MEMO – BID ADDENDUM

TO: All Contractors
DATE: 9/12/2025
FROM: Garrett Chubb, P.E.
Senior Project Manager
PROJECT NO.: 30002-69
CC: SouthStar at Mayfair Developer, LLC
RE: Mayfair – Promenade Trl
Bid Addendum No. 1

Mayfair – Promenade Trl

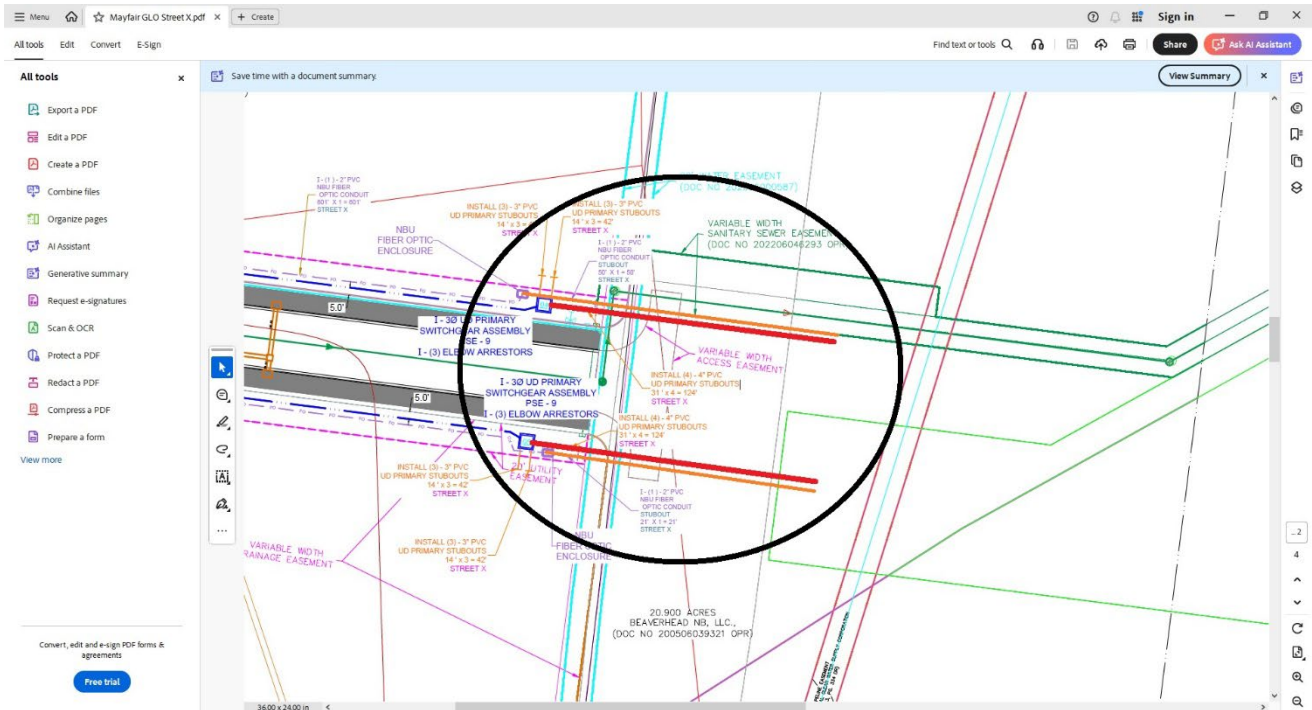
47. The bid form has been revised to include under the Street Improvements section a line item for 1 – 2" PVC SCH 40 (Fiber Optic) / 4 – 4" PVC SCH 40 (UD Primary Stubouts). Exhibit is included herein on the following page.
